**Modified Agenda**
**City of Dunnellon**
**Planning Commission Meeting**
**20750 River Drive, Dunnellon, FL 34431**
**April 19, 2016**
**5:30 p.m.**

# CITY OF DUNNELLON
# STAFF REPORT

**PROJECT NAME:** Wendy's Restaurant w/drive-thru

**PROJECT NUMBER:** SPL 2016-01, PZ1516-045

Wendy's Site Plan

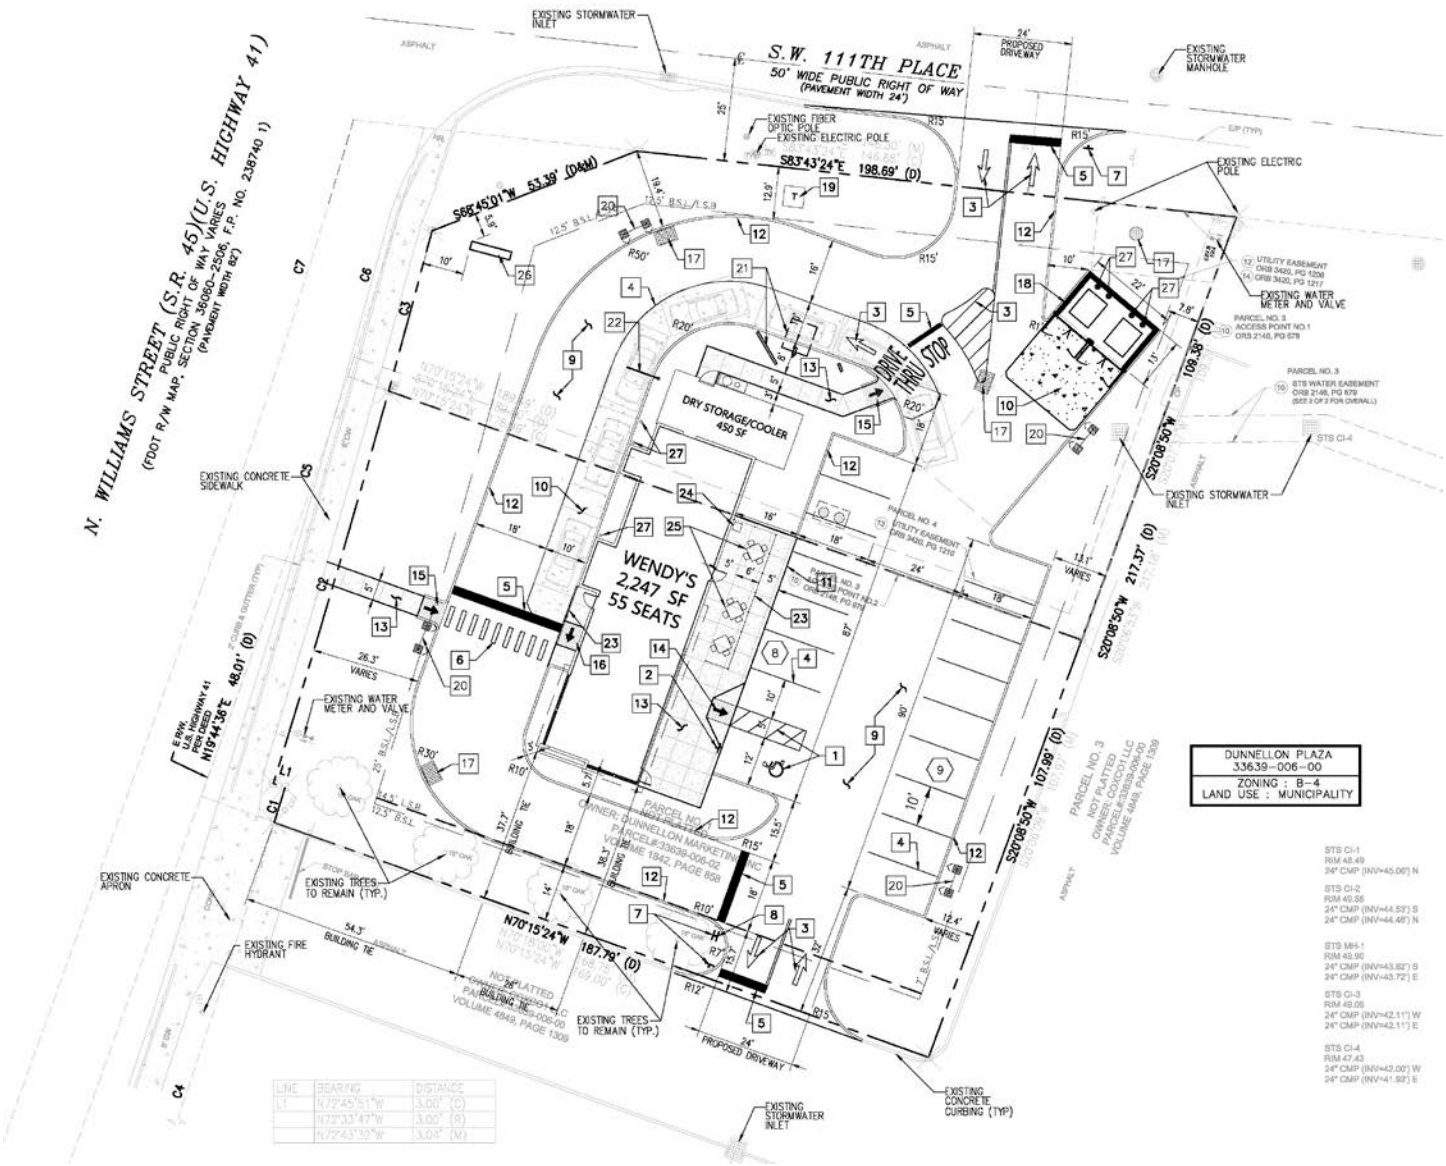
Building seating capacity 55 (indoors) + 12 (outdoors) = 67 seats divided by 4 = 16.75 required
17 spaces have been provided

**The Applicant meets the off-street parking requirements as set forth above.**

1. The Parking lot lane located to the East side shall be maintained at not less then 20 ft width with a vertical clearance not less then 13 ft 6 in. This is to qualify as the Fire Dept. access road.
2. During demolition and construction operation, an adequate level of fire safety shall be implemented. Included but not limited to fire extinguishers on site and removal of combustible debris.
3. All other components of the site plan appear to be adequate at this time.
4. No other comments.

Landscape Plan

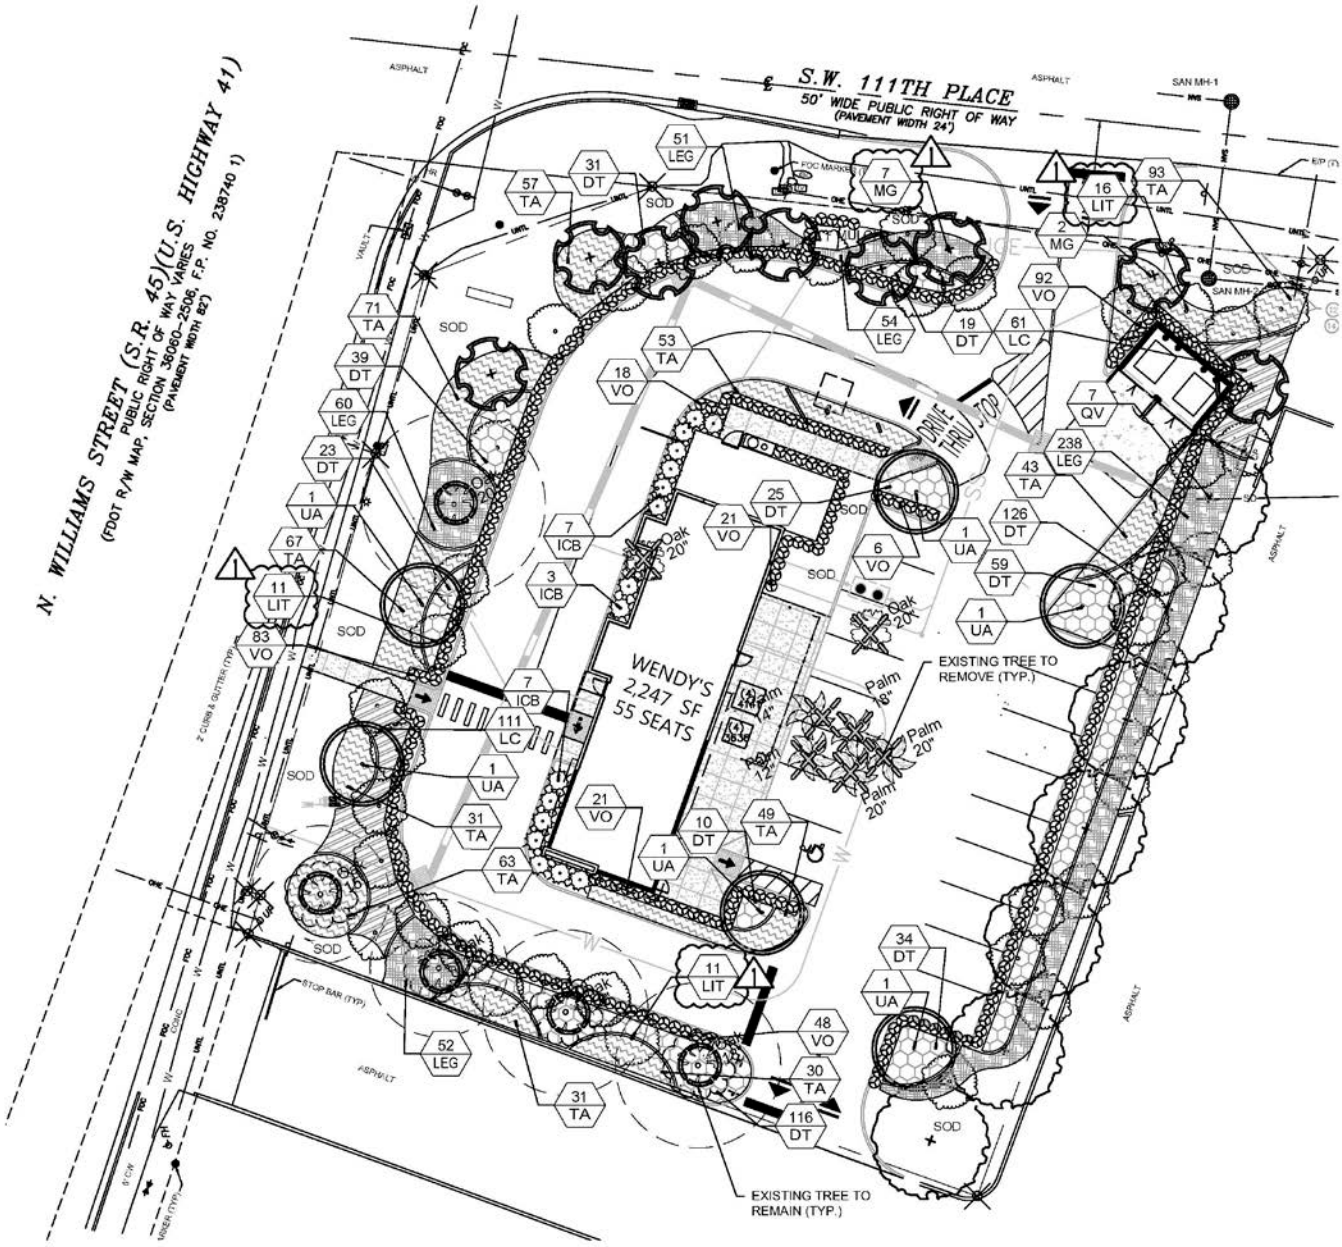
| | Front | Sides | Rear |
| Landscape Buffer Variance | 25ft | 12.5ft | 7ft |
| Landscape Buffer Provided | **26.3ft** | **12.9/14.5ft** | **7.8ft** |

**The Applicant meets the landscape buffer variance requirements as set forth above.**
